ST-HL-AE-1745

South Texas Project
Units 1 and 2
Docket Nos. STN 50-408, STN 50-499
Additional Annotated FSAR Changes
Concerning Section 3.6, Pipe Break Criteria

Attachment: Annotated changes to FSAR Section 3.6 and Q210.19N

CASE I OUTGOING LINES WITH NORMALLY CLOSED VALVE

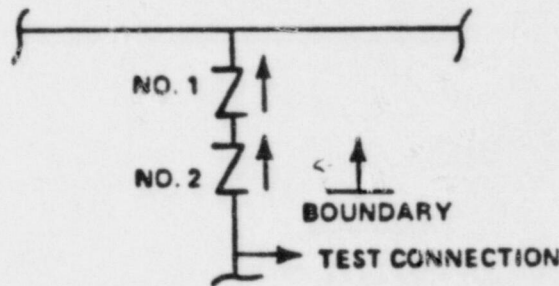
3.6.2.3.2.1 General - A LOCA is assumed to occur for a branch line break down to the second normally open automatic isolation valve (Case II, Figure 3.6.2-1) on outgoing lines and down to and including the second check valve (Case III, Figure 3.6.2-1) on incoming lines normally with flow. A pipe break beyond the ~~restraint~~ or second check valve does not result in an uncontrolled loss of reactor coolant if either of the two valves in the line closes.
